Keystone RV Company

SERVICE ADVISORY # 18-318

Dometic Furnace Wiring

Limit Switch Wire Rework Service Bulletin

1.1 Examining the limit switch wires

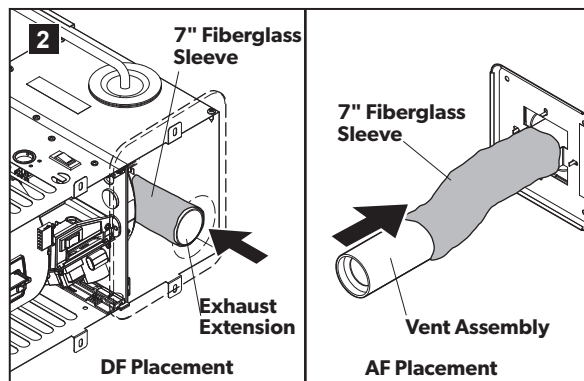
- Remove the vent assembly, and using a flashlight, look through the opening in the vent cover to inspect the exhaust vent area.
- Visually examine the limit switch wires for evidence of the following conditions:
 - Wires laying on the exhaust vent tube
 - Melting at any point along the length of the wire
- If either condition exists, contact the Dometic Technical Service department at 866-869-3118 and/or your OEM manufacturer for repair approval, prior to repairing any wires or continuing with this field repair.
- If no damage is present, proceed with this field repair.

1.2 Placing the sleeve on a DF/AF unit

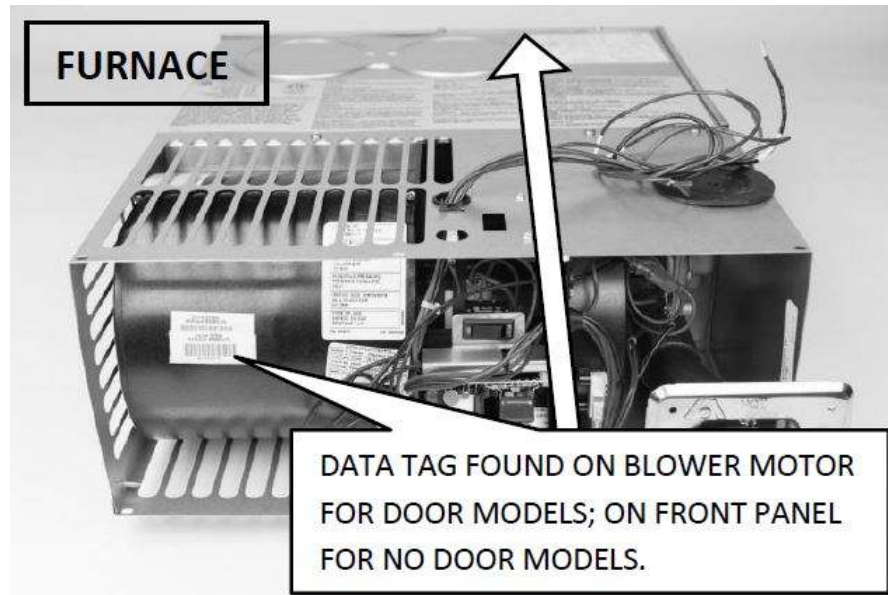
- Install the fiberglass sleeve:
 - For DF units: slide the fiberglass sleeve over the exhaust extension.
 - For AF units: slide the fiberglass sleeve over the vent assembly.
- Re-install the vent assembly.
